Rezoning Transportation Analysis

Petition Number: 2019-008

General Location Identifier: 08109921

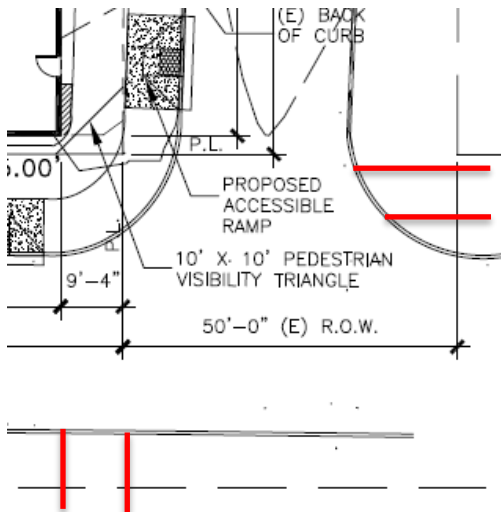
5. The petitioner should rebuild the receiving ramps at the corner of Seigel Avenue and East 15th Street to meet City of Charlotte and PROWAG standards.
